The Farmers Field, Seaview, Isle of Wight

Technical Note - Response to Additional  
Highways Information

21-0258

- 1.1 Cotswold Transport Planning Ltd (CTP) has been instructed by savethedonkeyfield.co.uk to prepare a Technical Note (TN) to review the additional highways information submitted in relation to the proposed construction of eight dwellings and formation of vehicular access on land, known locally as 'The Farmers Field', at Seagrove Farm Road, Seaview, Isle of Wight - LPA Ref (21/00779/FUL).

**Figure 3.1: Footway Width to Accommodate Pedestrians - MfS pg 68**

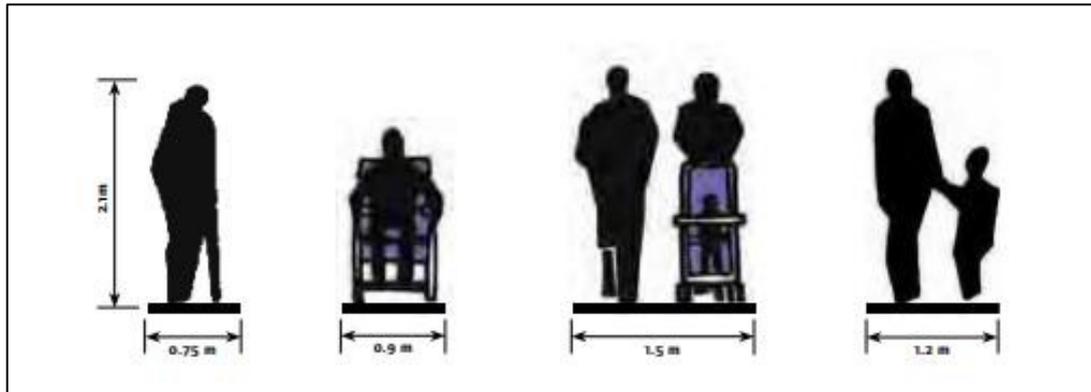
- 3.10 As detailed in **Figure 3.1** MfS indicates that a width of 1.5m is advisable to accommodate a wheelchair / pram user and an ambient person side-by-side. For someone who uses a wheelchair 0.9m is advisable and for a walking aid 0.75m is advisable. Inclusive Mobility (2005) references a person who uses two sticks or crutches, or a walking frame requires a minimum of 0.9m and a blind person using a long cane or with an assistance dog needs 1.1m.

- 3.11 The existing footways are severely restricted when pavement parking occurs and well below the recommended footway widths to suitably accommodate pedestrians as stated within MfS.

Figure 1 - Extract from CrahsMap (1999 to 2020)

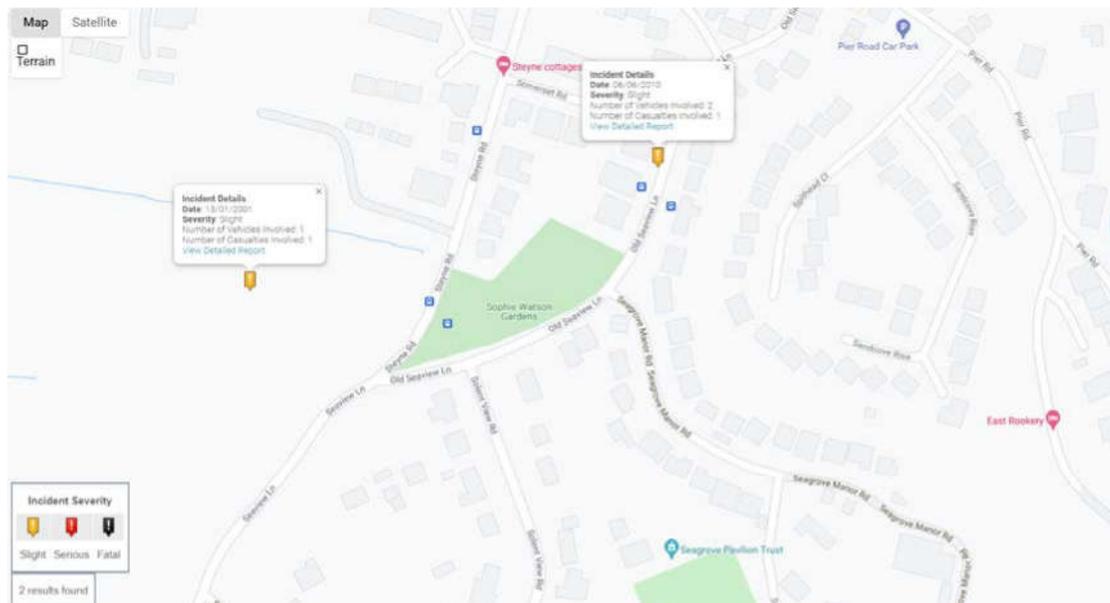
- 2.2 Taking the latter first, it should be noted that this junction is part of the adopted highway and that Steyne Road and Old Seaview Road provide the main routes to Seaview, with Old Seaview Road signposted at the junction as the main route to the shops, car park and centre of Seaview. While there are seasonal variations, the roads carry relatively low levels of traffic however and both corridors are also bus routes.

- 2.3 Furthermore, accident records over the last 22 years (since 1999) show that there has been no accident resulting in casualties at the junction, as illustrated on Figure 1, and that of the two accidents that have been recorded on the local highway, neither occurred at any of the local junctions. One was recorded in 2001 and the other in 2010.
